STAFF REPORT: MAY 8, 2024 MEETING
APPLICATION NUMBER: HDC2024-00181
ADDRESS: 441 W. WILLIS

PREPARED BY: A. DYE

SCOPE: ERECT MULTI-FAMILY BUILDING

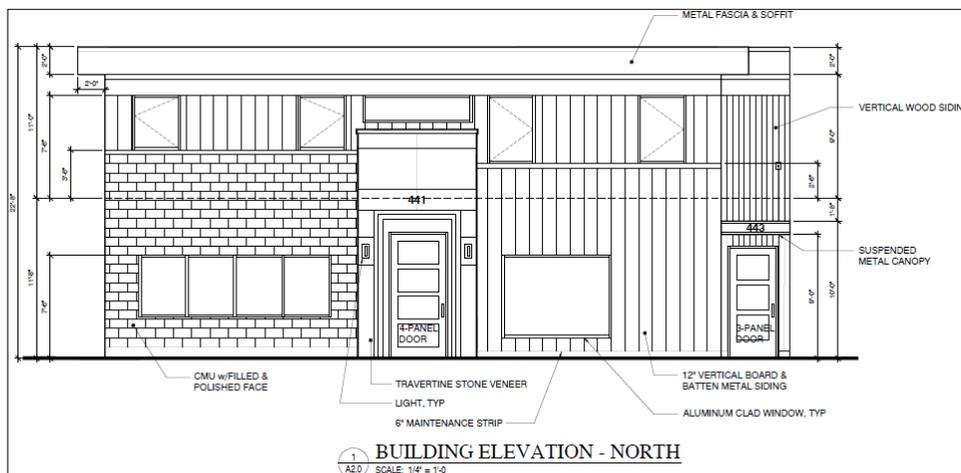
Element 4 - Rhythm of solids to voids in front façades. Despite a variety of building types, the overall impression is one of regular, repetitive openings arranged horizontally within façades.

The proposed building has asymmetrically placed window and door openings, coupled with different sized windows and sill heights. The use of vertical and horizontal wall materials separated by different transition heights doesn’t create a vertically or horizontally arranged façade.

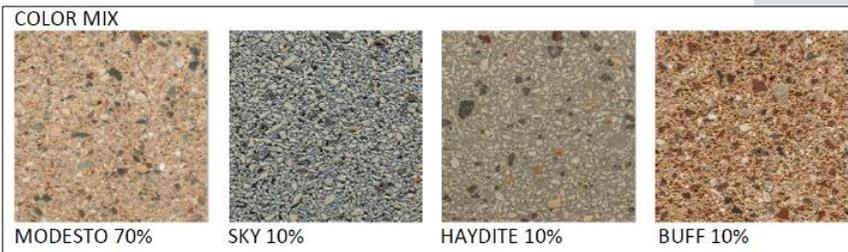
There is a vast difference in usage of materials and colors for the proposed structure.

Eight materials, with different surface finishes and colors* are proposed for the front façade.

- CMU (the four colors are distinctly different and do not read as a unified element – see Brick)
- Travertine
- Wood entry doors
- Aluminum-clad wood windows
- Metal siding
- Composite wood siding
- Metal fascia and soffit
- Six-inch tall maintenance strip. This element is at-grade and will be minimally visible. It is called out here because the material and color are not specified.

Staff's concern is how the multiple cladding materials relate to the district as well as to each other. In contrast to the above streetscape photo, which shows two dominate materials and colors per building, the subject property has five wall materials and eight colors.

Above left: Site plan – red line identifies front walls of buildings.

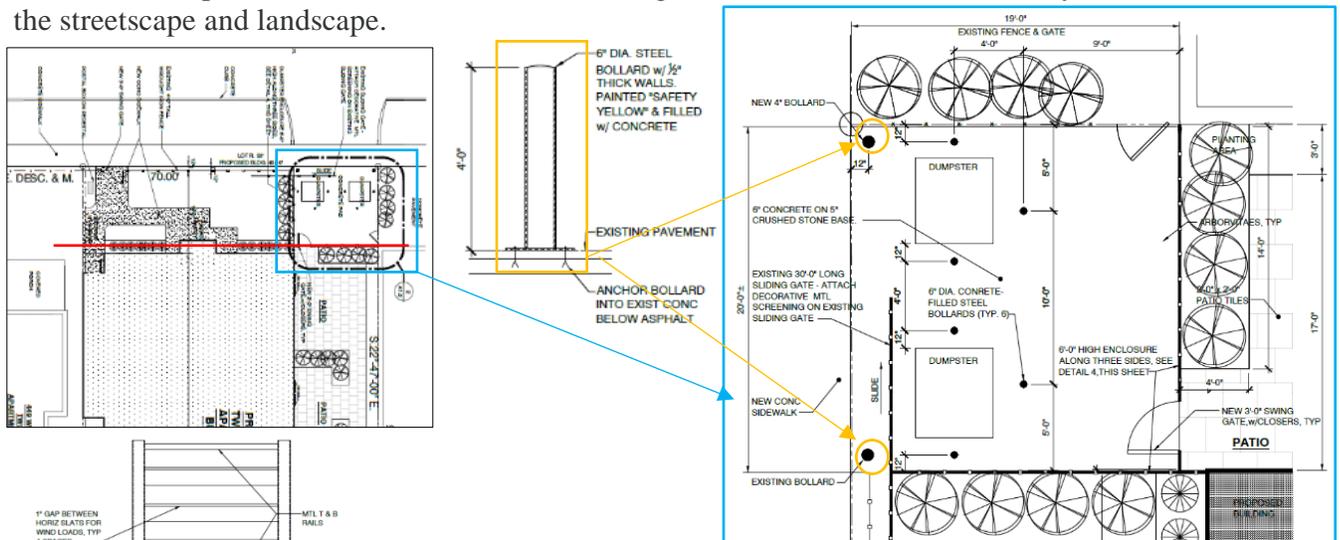
The part of the project that relates to where the structure is sited and enclosed by a transparent metal fence meets Elements 12 and 13. However, when looking at the complete application, which includes the design and placement of the trash enclosure, it is staff's opinion the project does not meet these two standards.

The site plan shows the front of the new building in line with the commercial building to the east, but conversely, the trash enclosure sits forward of both buildings. It is located in the front yard space of 441 W. Willis and is enclosed with a fence constructed of solid, plastic panels. The shine and flatness of the manufactured material does not adequately match the profile, dimensionality, and appearance of wood or metal, the most common materials used in fencing and is incompatible for use in the historic district (and is in conflict with *Element 7 – Relationship of Materials* and *Element 8 – Relationship of Textures*). The placement of this enclosure is incongruous to this district and destroys the site line of the streetscape and landscape.

Left and below left: Elevation and cut sheet for enclosure fence “walls”.

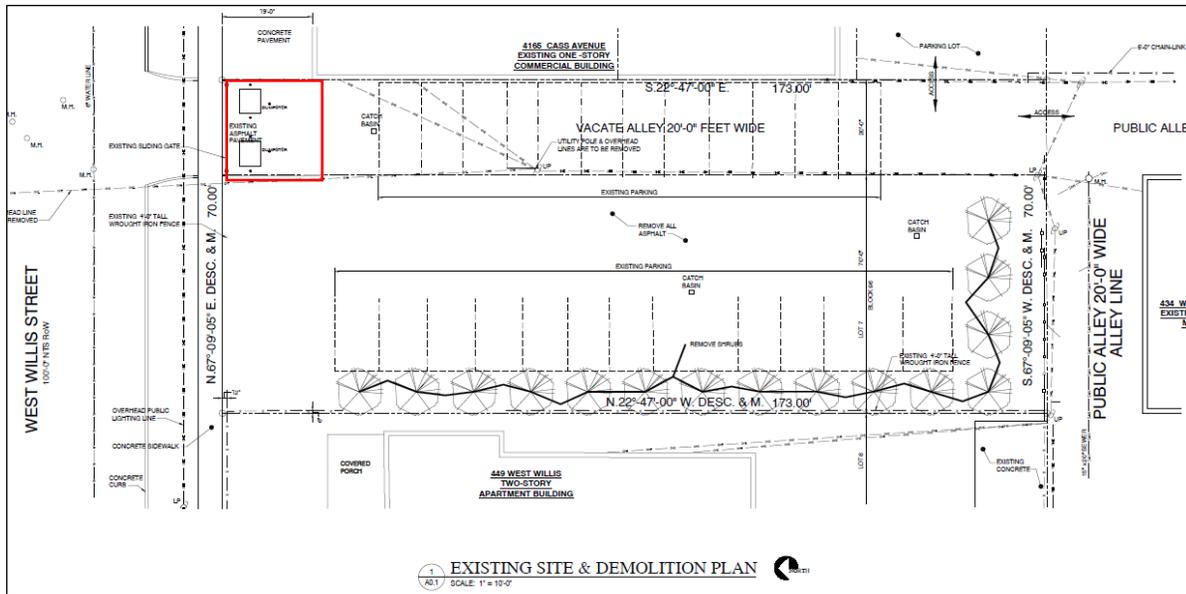
Bottom right: Applicant rendering showing trash enclosure and front yard fencing. Staff added orange circles to denote location of bollards, based on the site plan.

- The solid walled trash enclosure at the front sidewalk is an incongruous placement within the district. The enclosure eliminates a portion of the front yard of this lot, disrupting the walls of continuity and open space that characterizes the streetscape of the residential block. The selected enclosure material is plastic; the shine and flatness of the manufactured material does not adequately match the profile, dimensionality, and appearance of wood, and is therefore incompatible for use in the historic district.

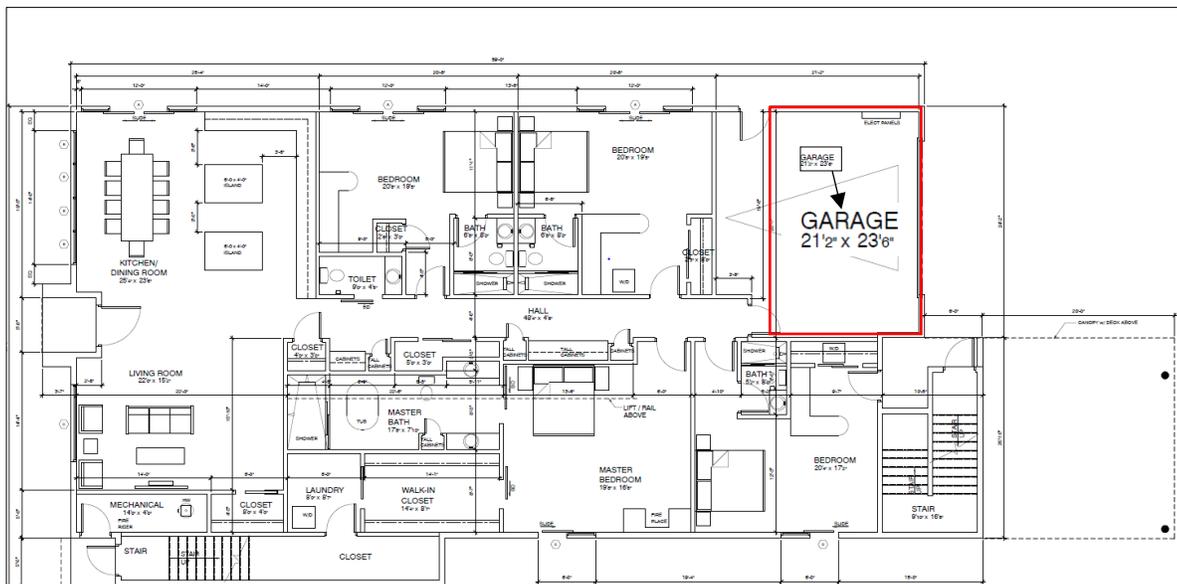
The proposal includes twelve surface parking spaces, but the application doesn't call out the additional two indoor parking spaces designed at the back of the building (which are noted on the first floor's floor plan). Therefore, fourteen spaces were designed for the four-unit building. The applicant states zoning requires one parking space per unit and they wanted to achieve one space per bedroom. Counting the bedrooms: one four-bedroom unit, one three-bedroom unit, and two, two-bedroom units, there are eleven bedrooms in the building. It is staff's opinion the applicant could consider locating the trash enclosure at the top or bottom corner of the parking area, where it could open to the public alley. This would require the loss of probably two parking spots, but the project would stay within the goal of one parking space per bedroom.

Staff copied the space of the trash enclosure at the sidewalk to show how the trash enclosure at the alley could be accommodated by the reduction of two parking spots. This new location would require a redesign of the sliding gate parking lot enclosure; but more importantly, would keep the front yards and streetscape on Willis intact. In the 2020 new building application (site plan on page 2 of this staff report), the trash enclosure was proposed at the southeast corner of the rear lot.

Applicant elevation and rendering. The windows at 449 W. Willis are depicted as casements, but they are 1-over-1 double-hung units.

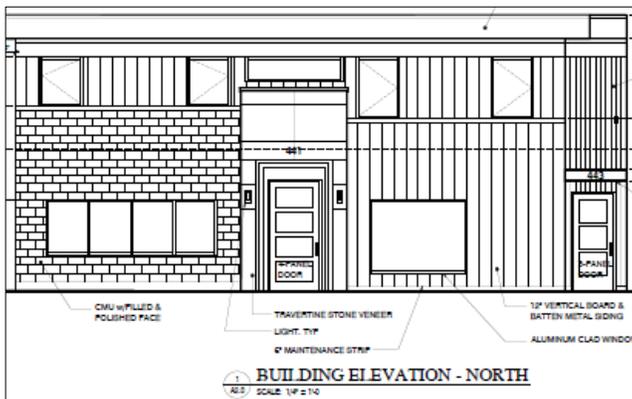
The 3-1/2- and 5-1/2- story apartment buildings (469 and 479 W. Willis) offer highly symmetrical designs, as does the 2-1/2 story dwelling (455 W. Willis). The balanced massing and consistent window/door openings are emphasized by singular contrasting window trim. At 449 W. Willis, the building next door to the subject property, the asymmetrical massing of the house is balanced by the vertical and horizontal alignment of the window and door openings.

The applicant’s design for the front and side walls is a contemporary design that, in staff’s opinion, does not offer a level of balance, due to the irregular placement, size, and operation of the windows, as well as the competing patterns, dimensions, and materiality of the exterior materials. There isn’t a strong vertical or horizontal expression, which is inconsistent with the rhythms and patterns of the historic and newly constructed buildings on this street.

Above left: The applicant’s site plan, using the same red line, shows the adjacent house (449 W. Willis) being significantly set back from the sidewalk. This gives the incorrect impression that the new building will break the rhythm of setbacks for this block.

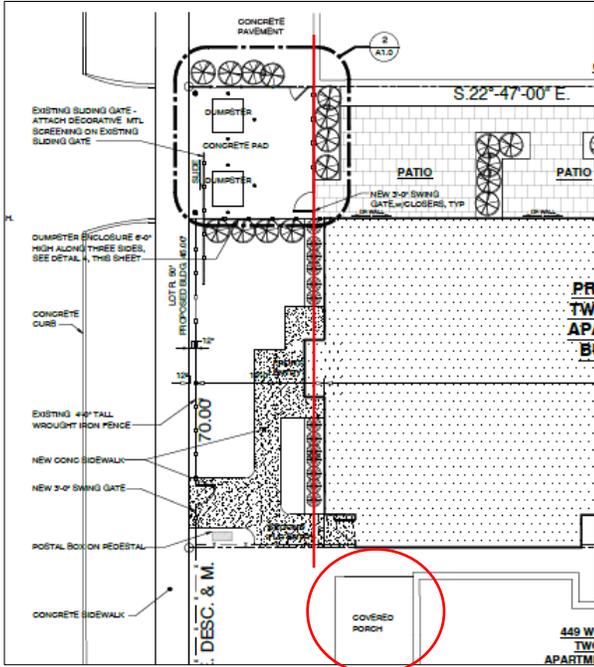
Comparing the site plan and renderings to the aerial view of the buildings, it is staff’s opinion the dwelling at 449 W. Willis isn’t drawn in the correct location on the site plan and renderings. The front wall of the building proposed at 441 W. Willis should be in line with, or only slightly in front of, the adjacent structures - the rhythm of building setbacks will effectively remain intact.

The site plan submitted with the 2020 application for a new building (shown on page 2) is drawn correctly; staff recommends the site plan be revised accordingly.
